Accessory Kit No. AK-105B (Supersedes Accessory Kit No. AK-105A dated March 11, 1971

Heated Pitot Tube Accessory Kit

All Model AA-1, AA-1A and AA-1B aircraft

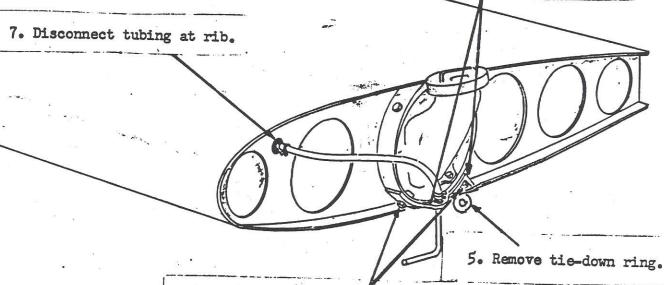
Install the heated pitot assy. as instructed on Figure's 1 through 5.

Figure 2. Conventional Pitot Tube Removal.

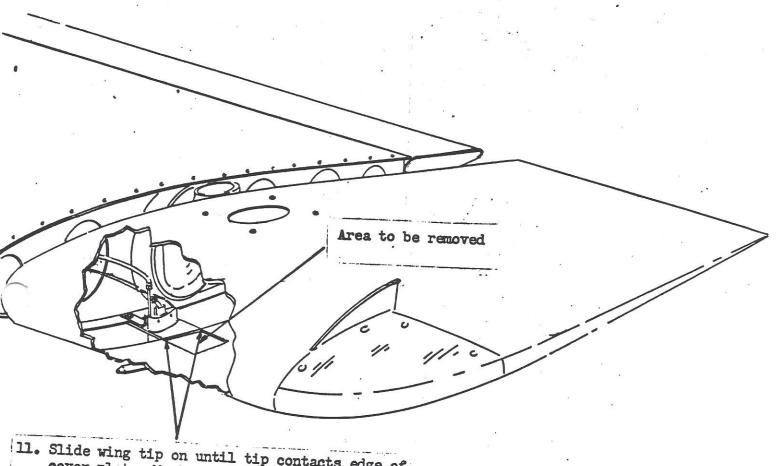
8. Carefully remove pitot tube and tie-down ring bracket. Reinstall tie-down ring bracket, nut and tie-down ring. Install washers between bracket and rib to take up space left by removal of original pitot tube.

6. Remove the two lower nuts from bottom of spar being careful not to disturb tank seal. Remove Pro-seal around nut and bolt heads only.
